**BULL HILL
TREE FARM
PONDS**

**Marlborough, Connecticut
May 1990**

*Eastern Connecticut
Environmental Review Team
Report*

RE: POND DESIGN EVALUATIONS FOR "BULL HILL TREE FARM"

WATERSHED BOUNDARY

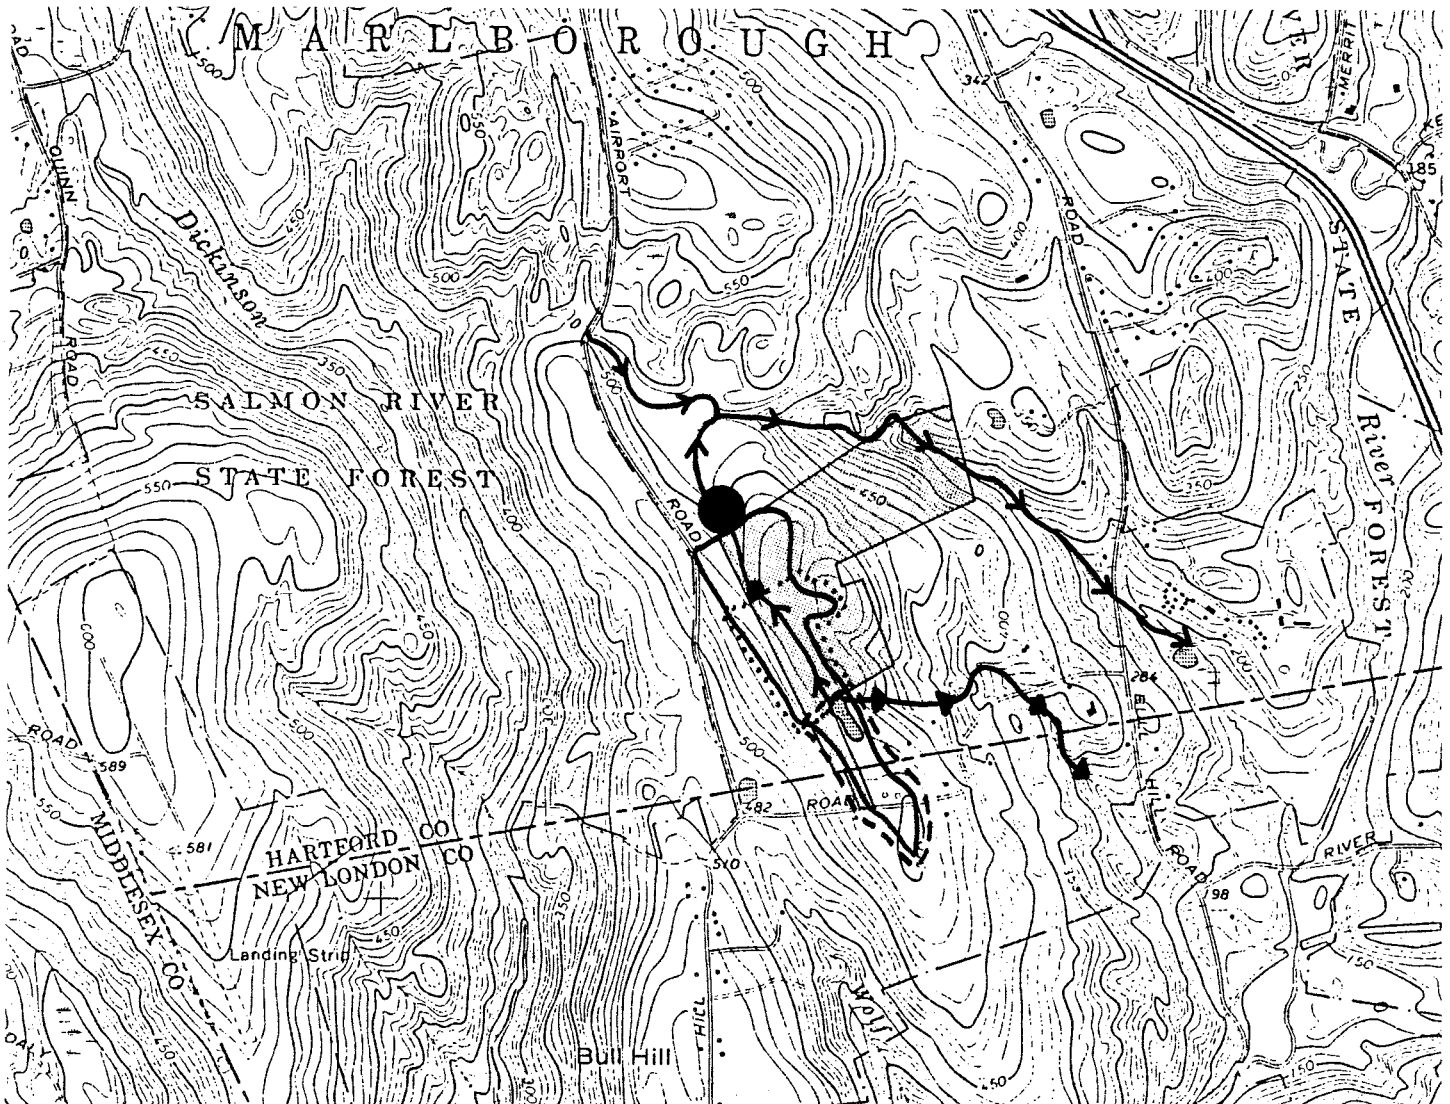
At its intersection with the northern property line, the intermittent streamcourse in the western parts of the Somers Property originally drained an area estimated to be about 47 acres. However, since the outlet for the Lesnewsy Pond has been diverted eastward, the drainage area to the design point mentioned in the preceding sentence is reduced to about 33 acres.

Present plans indicate that two ponds, referred to as "North" and "South" would be excavated in tandem in the drainageway and comprise ± 20 acre-feet. Using the method described in the preceding paragraph a drainage area of at least 35 acres would be needed to supply the pond(s). Locating "North Pond" in the northcentral parts of the drainageway, it is estimated that the drainage area of the ponds would be about 23 acres. This drainage area does not include the drainage area that feeds the Lesnewsky Pond, which is calculated to be about 14 acres. As one can see, there is a shortfall of about 12 acres that would be required for a drainage area feeding a 20 acre foot pond using the SCS guideline. This shortfall could be addressed by (1) downscaling the size of the pond(s) or (2) by re-routing the outlet stream for the Lesnewsky Pond back to its original course. The latter would increase the drainage area to ± 37 acres.

It is recommended that the pond proposals be scaled down to accommodate the aforementioned wetland restoration and to be more compatible with the contributing drainage area.
